Groundwater Remedy Phase 1 Construction, PG&E Topock Compressor Station, Needles, California

Work Variance Request – MW-20 Bench Brine Tanks Containment Upgrade for Use by Remedy

Variance Request No.: 1

Location: MW-20 Bench

CONTAINMENT AREA PLAN
1"=5'

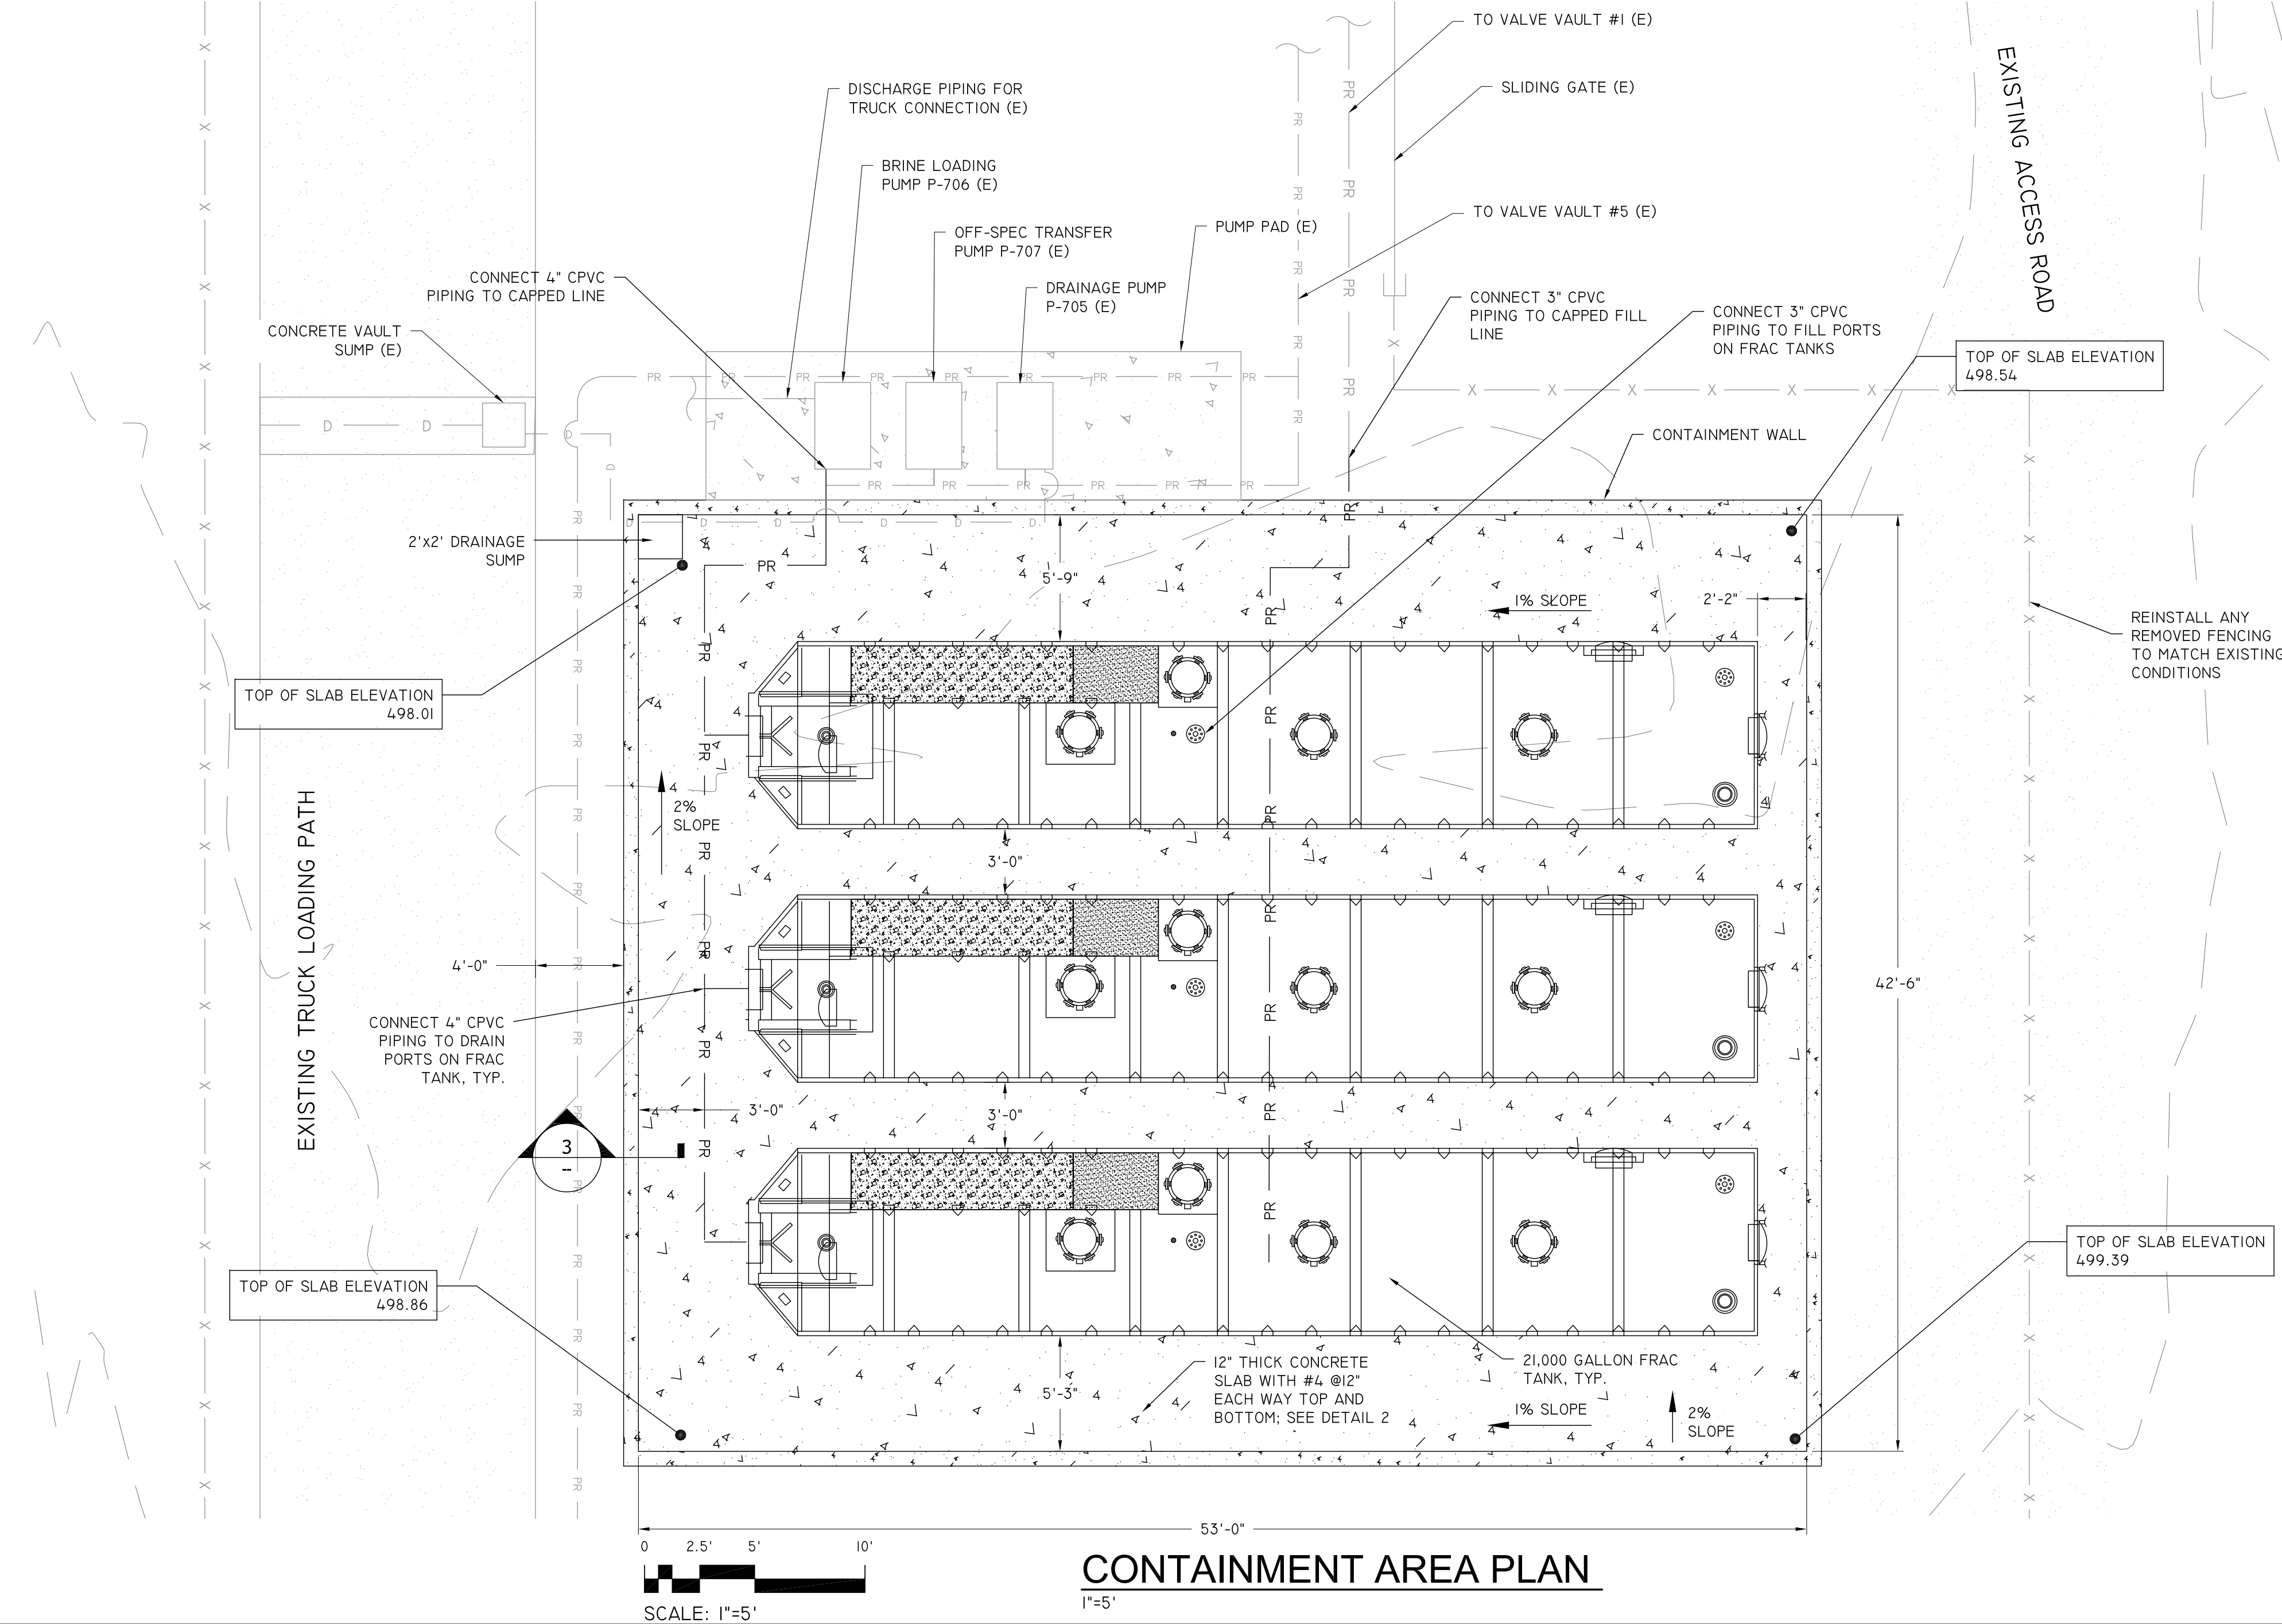
1. **Upgrade the existing lined containment to concrete** - The original synthetic liner material has degraded from exposure to UV light, heat, and abrasion and must be replaced. PG&E proposes to replace the synthetic-lined containment (including K-rails) with a concrete containment to support the groundwater remedy. See attached drawing with details of the proposed concrete containment. The proposed concrete color will be desert tan, information of proposed concrete color will be submitted to the agencies for review. The proposed concrete material will be similar to the material of the truck lane in the final remedy design (see Appendix E, Section 033 00, Cast-In-Place Concrete).

2. **Shorten the length of the containment** - This containment will have the same height as the existing containment, but with a slightly smaller footprint (the length is 5 feet shorter). This smaller footprint still meets the required volume for a secondary containment, and allows for more space for remedy construction at the tight MW-20 bench.
